Our Ref : A200151/PA118169/P2160670
Cross Ref : PA65397
Enquiries : Tom Wenbourne Senior Planning and Development Compliance Officer

AMENDED CONDITIONS 2, 4, 17 & 43 OF P2160670 - INDUSTRY - EXTRACTIVE (AGRICULTURAL LIME) AT Lot 9005 Eden Road Nullaki WA 6330

I refer to your request to amend conditions 2, 4, 17 & 43 for the above-mentioned application, submitted to the City on 20/07/2023.

drawing no
21980-23C

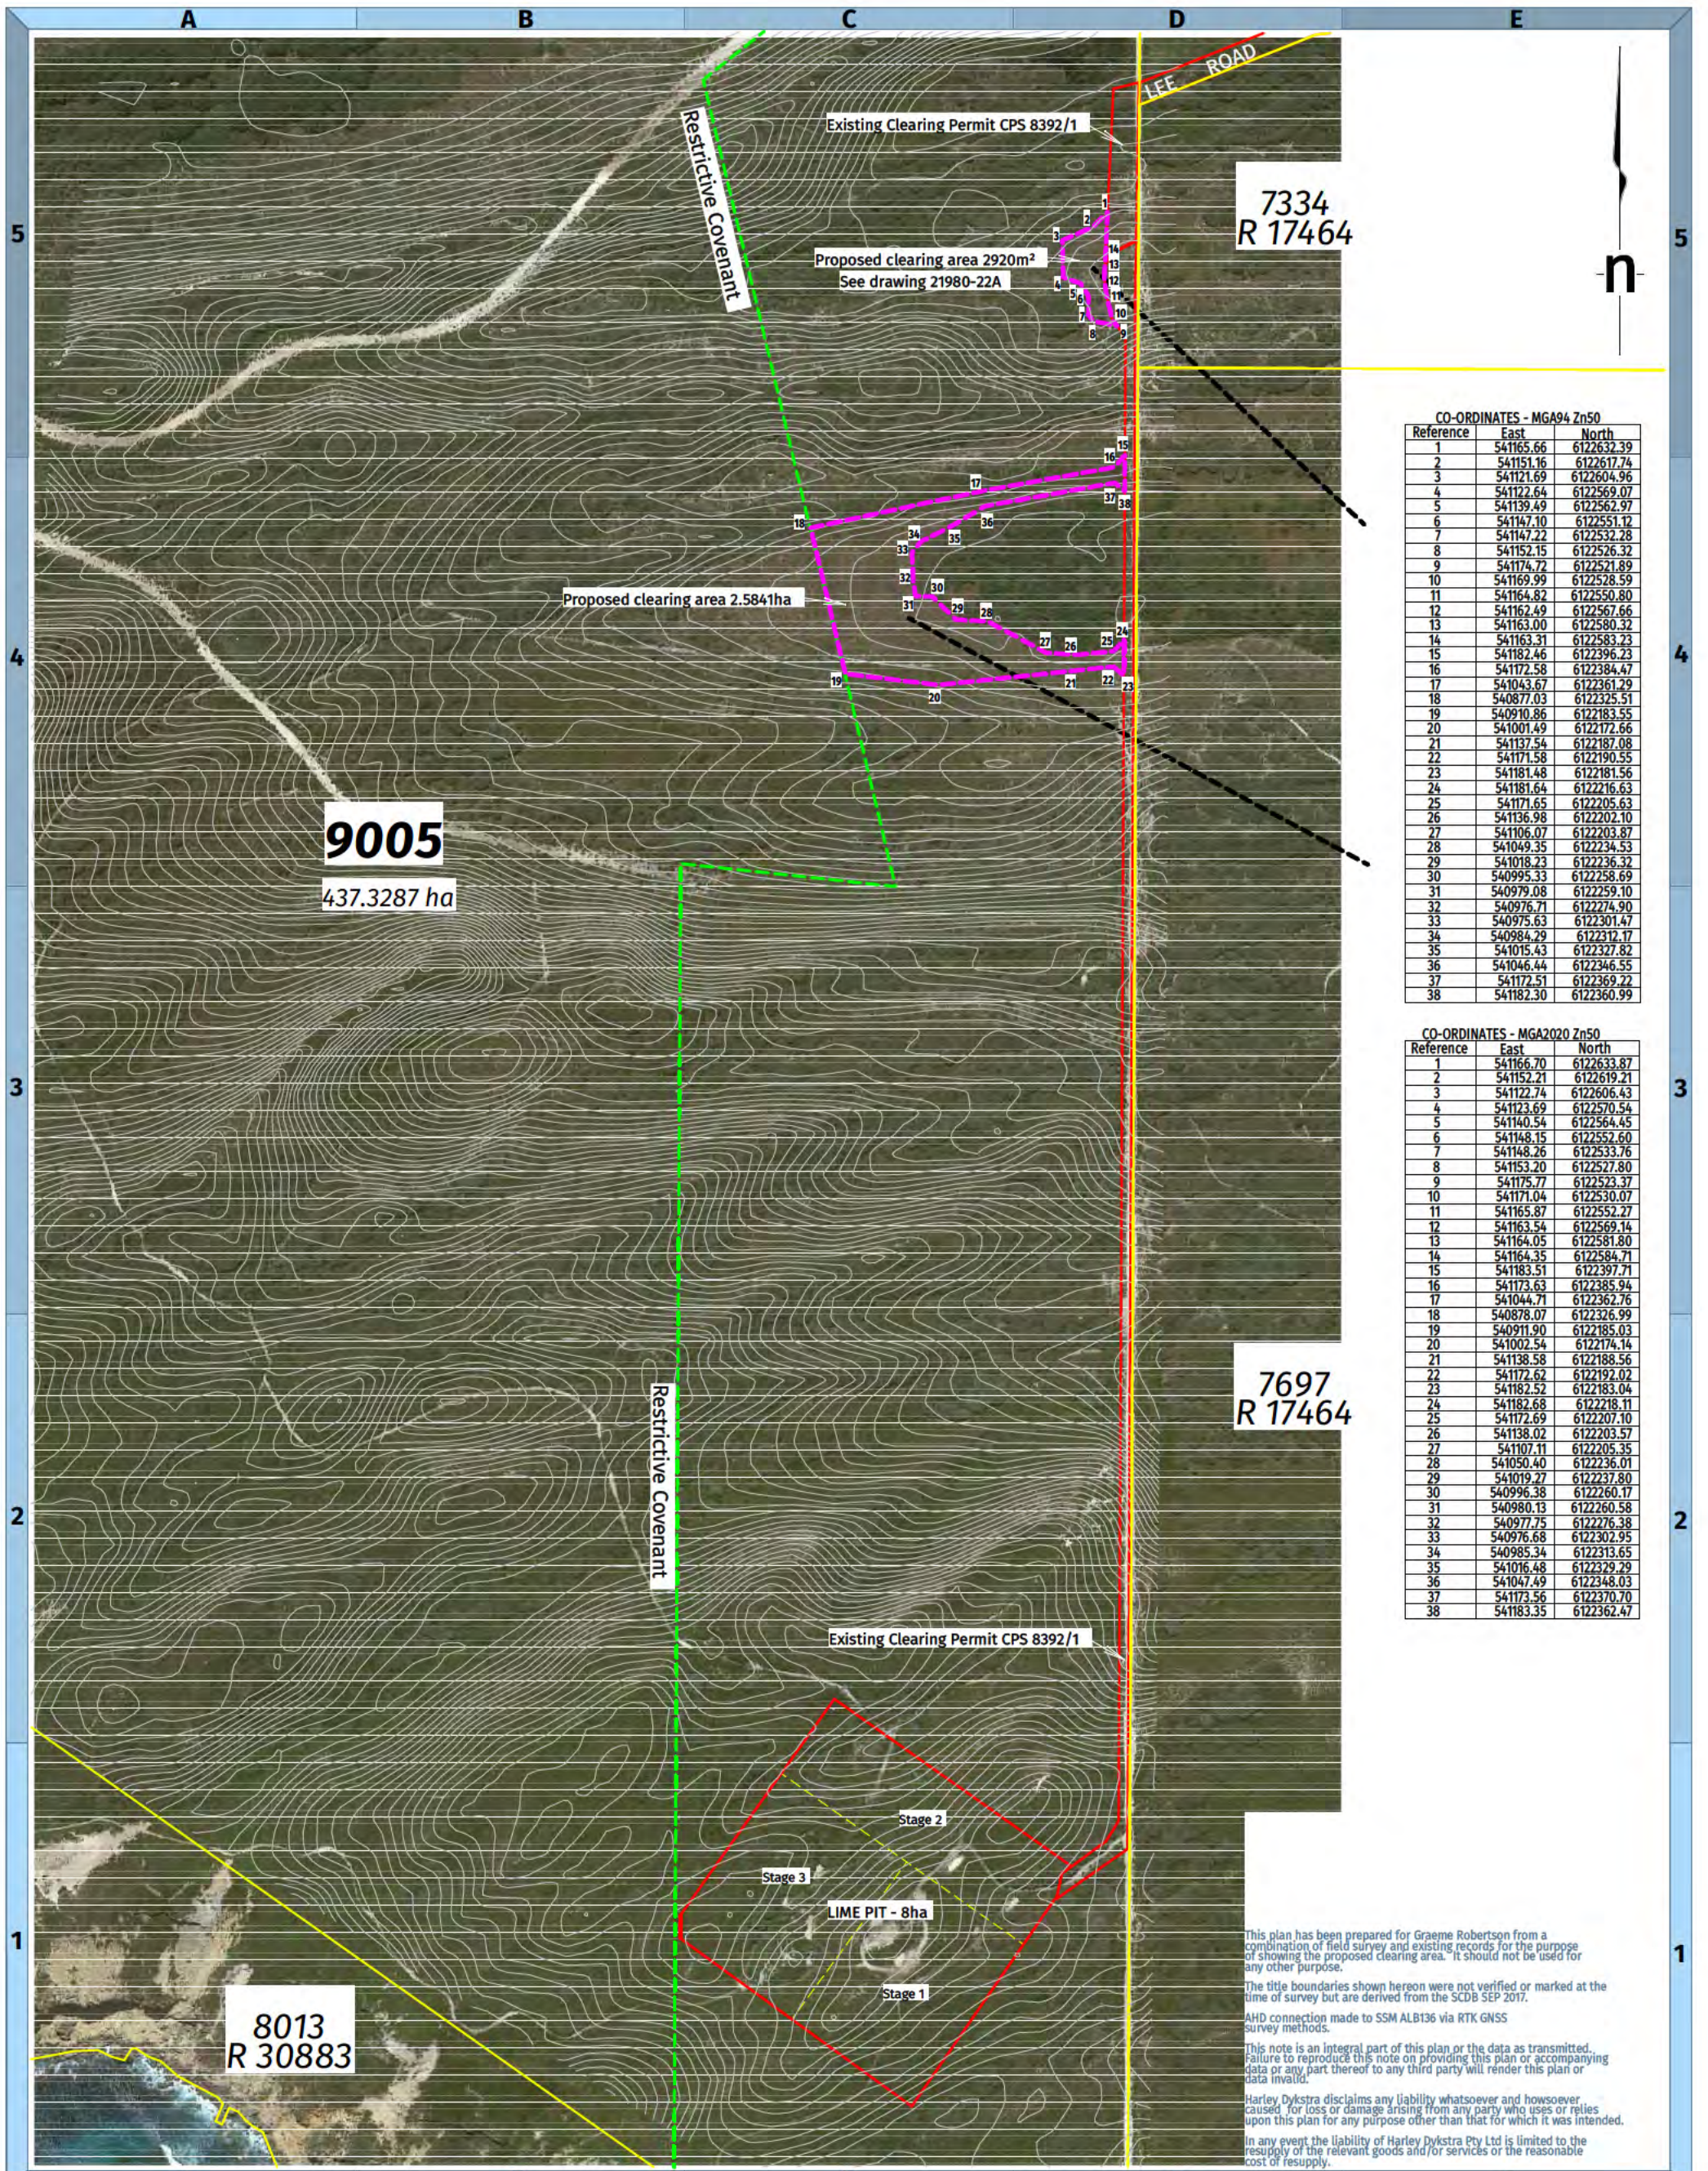
2. The Industry – Extractive activity shall be contained within the areas as depicted on Drawing number 21980-23C dated 11-10-2023 as follows:

Area A – Excavation, processing/screening and storage of lime and stockpiled overburden shall be contained within the 8 hectare area (Area A). A maximum of 4 hectares of Area A shall be open and used for these activities at any one time. The perimeter of the area to be worked must be pegged and clearly marked to ensure that all earthworks are contained within the approved area.

| DRAWING NUMBER | 2530-01-300 |

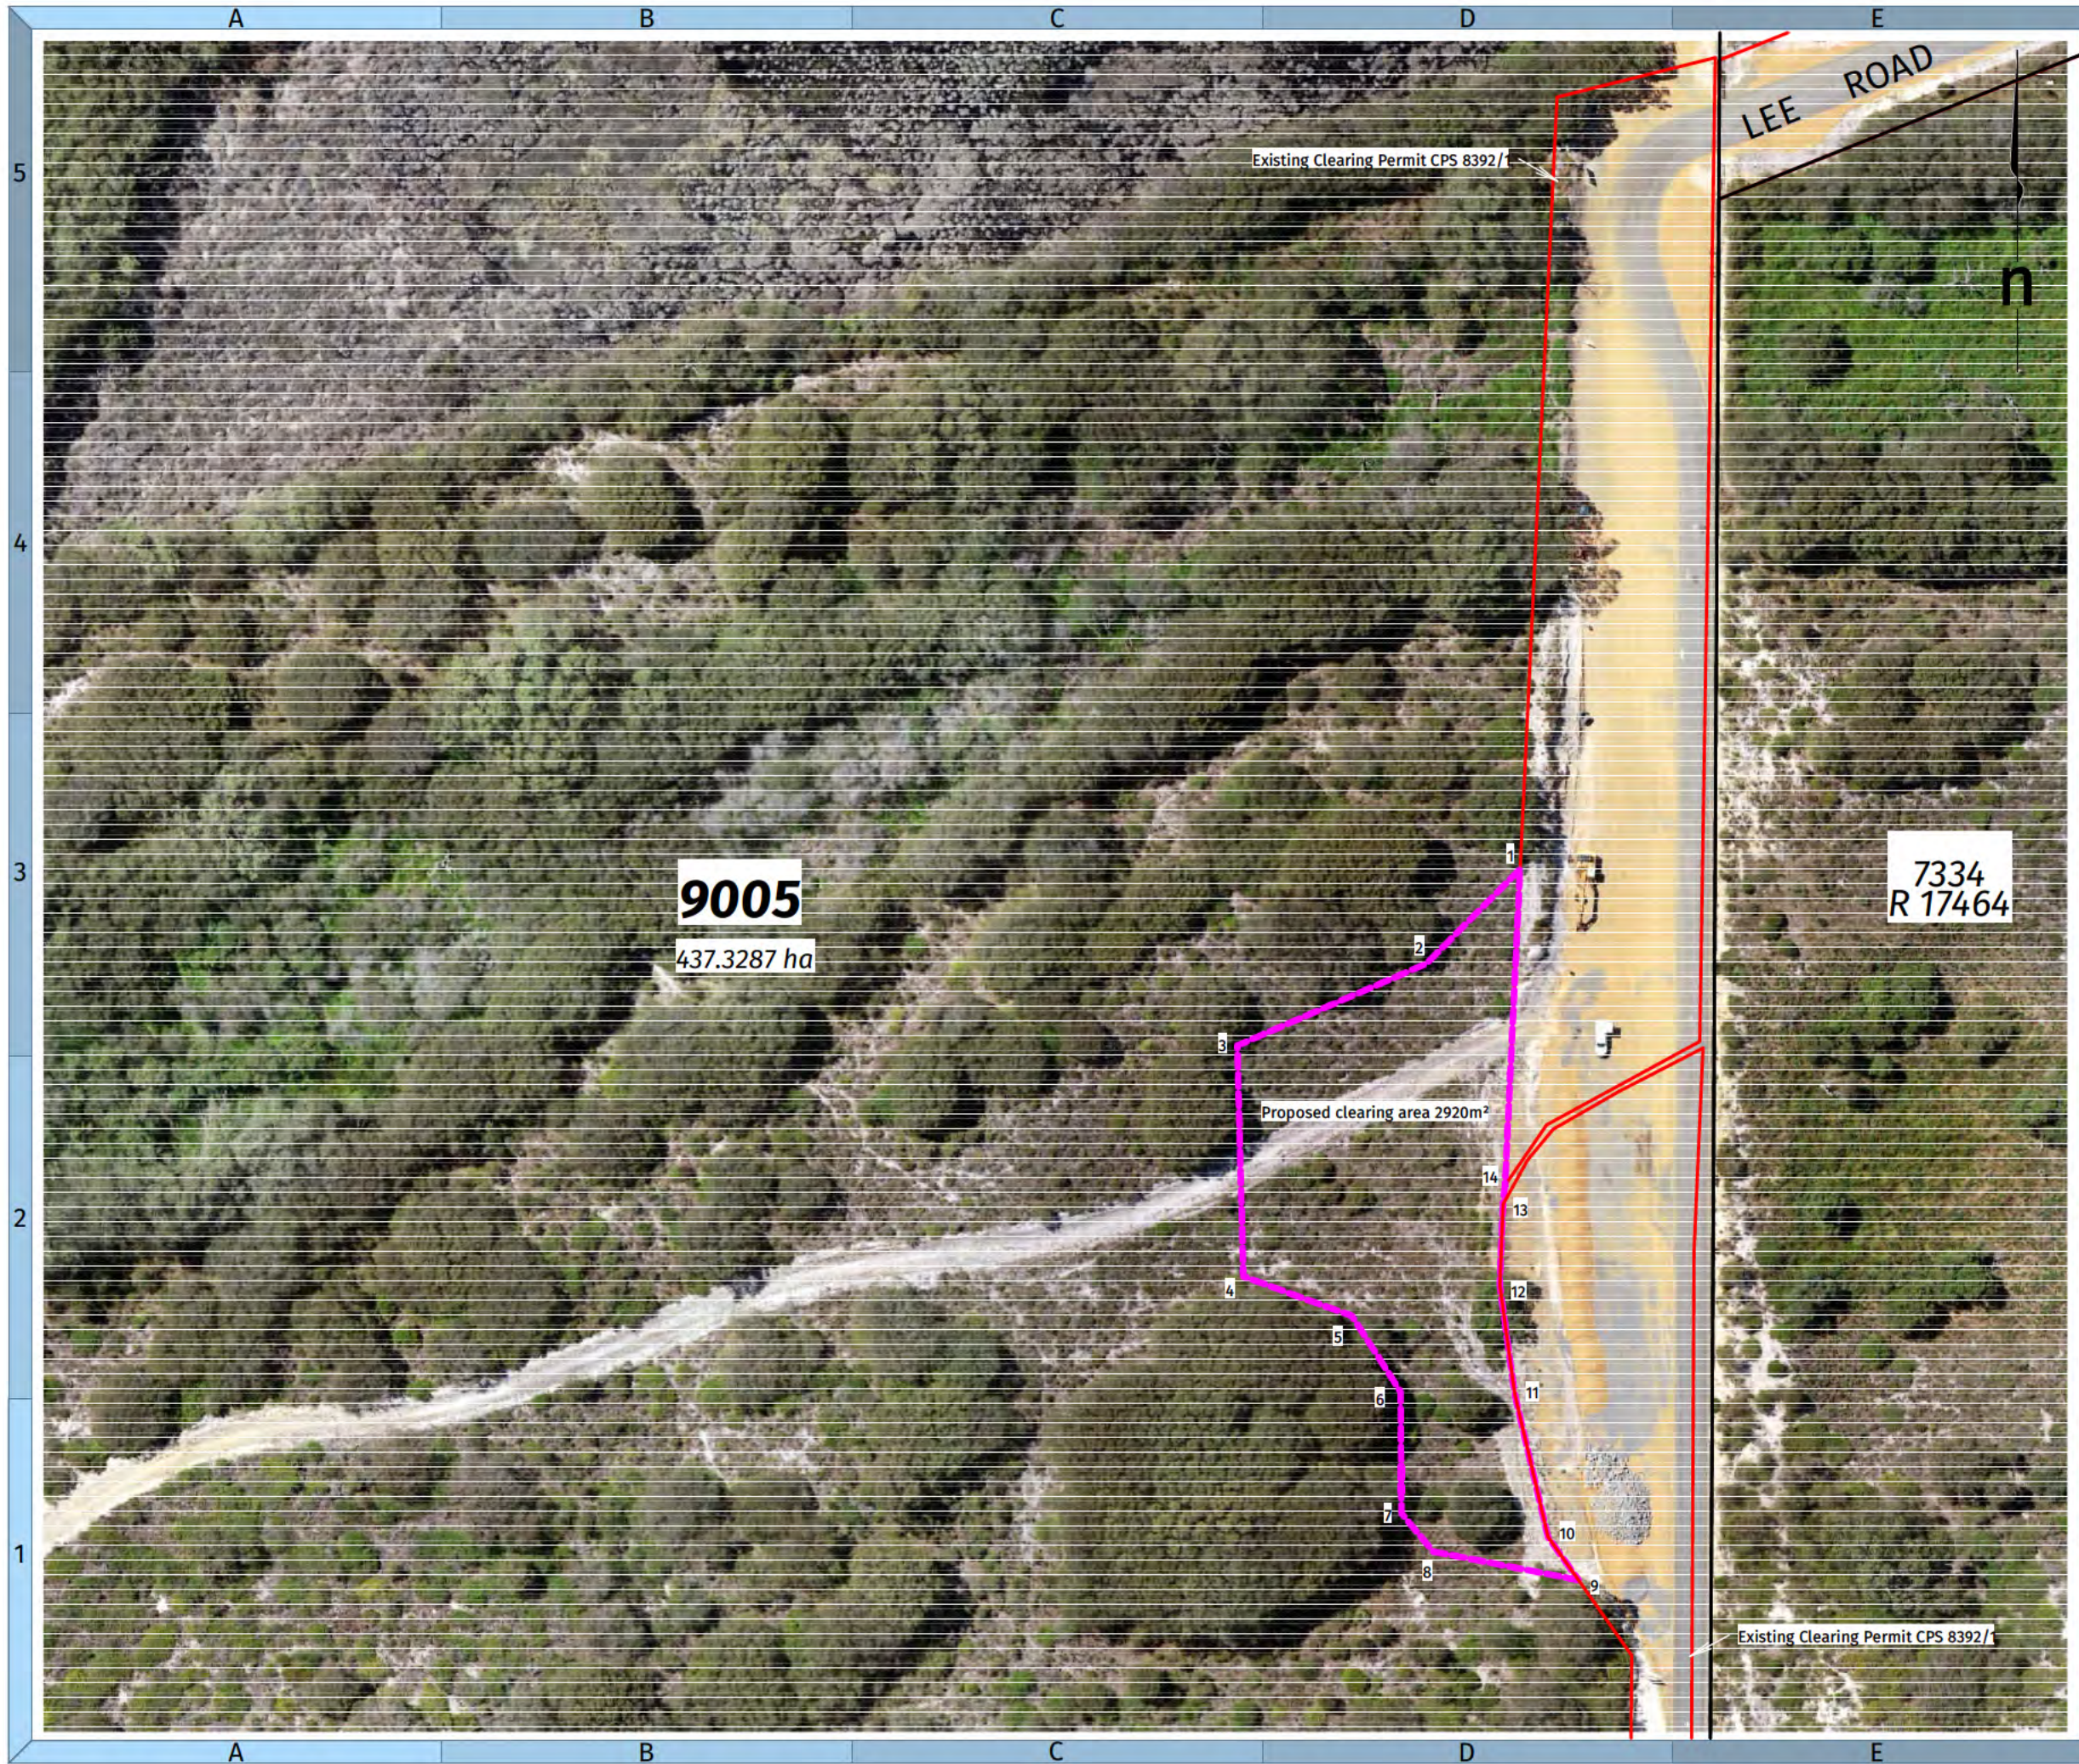
Area B – Stockpiling of lime and loading of road transport vehicles for haulage offsite shall be contained within Area B as depicted on Drawing number 21980-14E dated 11-10-2023 and Drawing number 2530-01-300 F dated 17.10.23. The stockpiles within the areas indicated on Drawing number 2530-01-300 F shall not exceed a height of 6m.
